## CHANGE REQUEST

25.427 **CR 102** rev 1 Current version: 6.1.0

<b>Title:</b>	☞ E-DCH Frame format update		
<b>Source:</b>	☞ Nokia		
<b>Work item code:</b>	☞ EDCH-lurub	<b>Date:</b>	☞ 09/03/2005
<b>Category:</b>	☞ <b>F</b>	<b>Release:</b>	☞ Rel-6
	<p>Use <u>one</u> of the following categories:</p> <p><b>F</b> (correction)</p> <p><b>A</b> (corresponds to a correction in an earlier release)</p> <p><b>B</b> (addition of feature),</p> <p><b>C</b> (functional modification of feature)</p> <p><b>D</b> (editorial modification)</p> <p>Detailed explanations of the above categories can be found in 3GPP <a href="#">TR 21.900</a>.</p>		<p>Use <u>one</u> of the following releases:</p> <p>Ph2 (GSM Phase 2)</p> <p>R96 (Release 1996)</p> <p>R97 (Release 1997)</p> <p>R98 (Release 1998)</p> <p>R99 (Release 1999)</p> <p>Rel-4 (Release 4)</p> <p>Rel-5 (Release 5)</p> <p>Rel-6 (Release 6)</p> <p>Rel-7 (Release 7)</p>

## 5.11 Generation of subframe number [FDD]

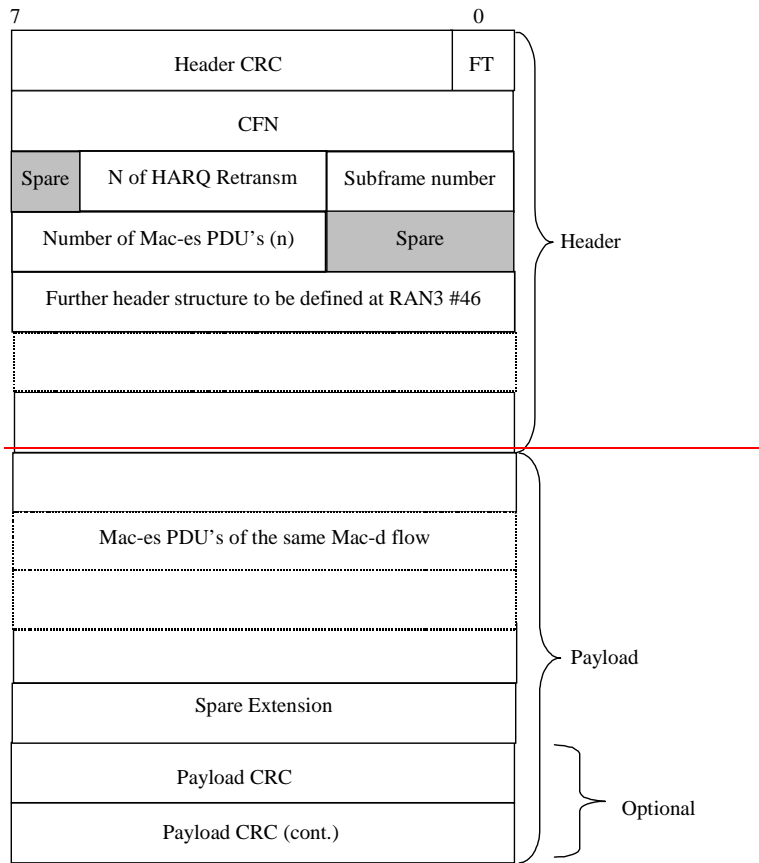
The *CFN* and *Subframe Number* IE's values in the E-DCH Data Frame shall reflect the CFN and subframe number when the payload in the E-DCH Data Frame was [correctly](#) received on the Uu. The subframe number is for 2 ms TTI set to values {0-4} and for 10 ms TTI set to {0}.

Figure 11a: E-DCH UL DATA FRAME structure

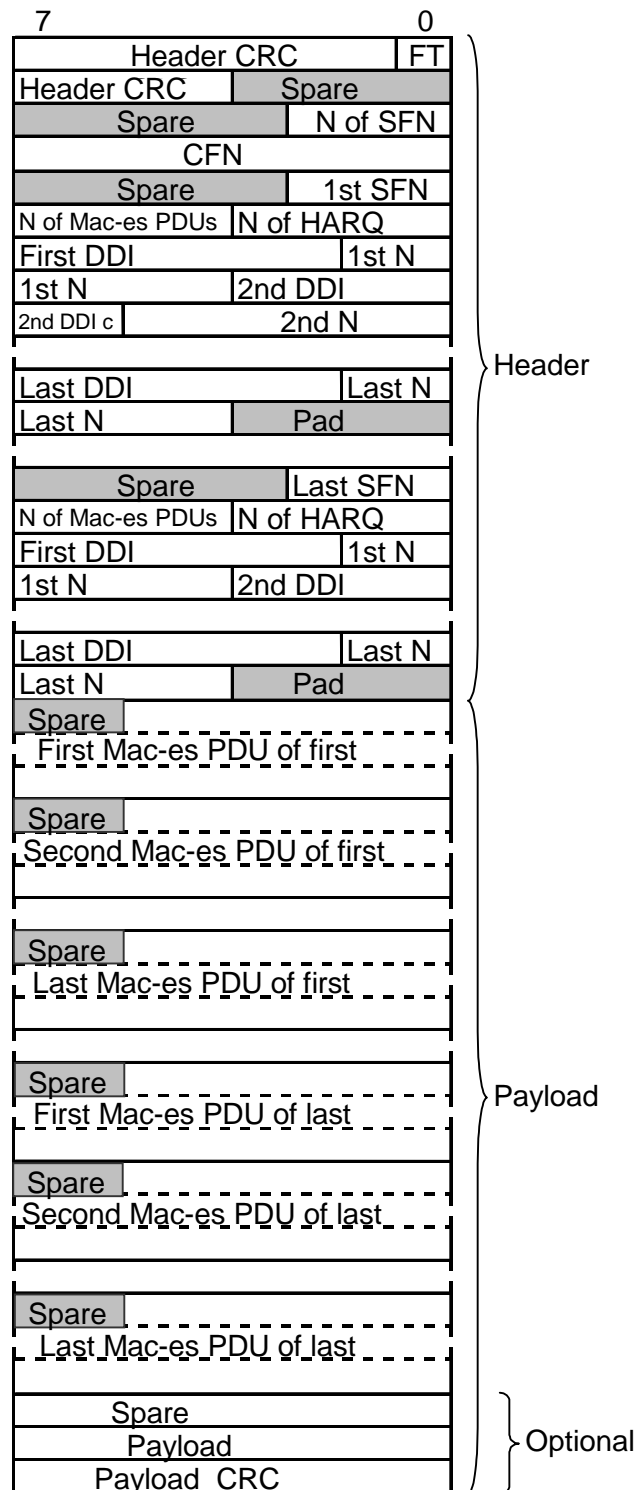
<b>Reason for change:</b>	☞ Update of the E-DCH Frame format in the lub/lur User Plane Protocol		
<b>Summary of change:</b>	☞ The “padding” field (2 bits) located at the of MAC-es PDUs in the frame payload is changed to “spare” bits as the length of the field is always 2 bits and as it is always included. <ul style="list-style-type: none"> <li>- The position of spare bits is changed to the beginning of the MAC-es PDU in the frame payload.</li> <li>- Procedural text which explains the “padding” field was deleted as it is no longer applicable.</li> </ul> <hr style="border-top: 1px dashed black;"/> Update of the E-DCH Frame format		
<b>Consequences if not approved:</b>	☞ The frame payload is not optimal from the processing point of view

When there is an odd number of DDI + N field pairs for a subframe, then 4 bits padding is used as shown in the figure in order to have the octet aligned structure.

If a Mac-es PDU does not fill an integer number of octets, then bit padding is used as shown in the figure in order to have the octet aligned structure.
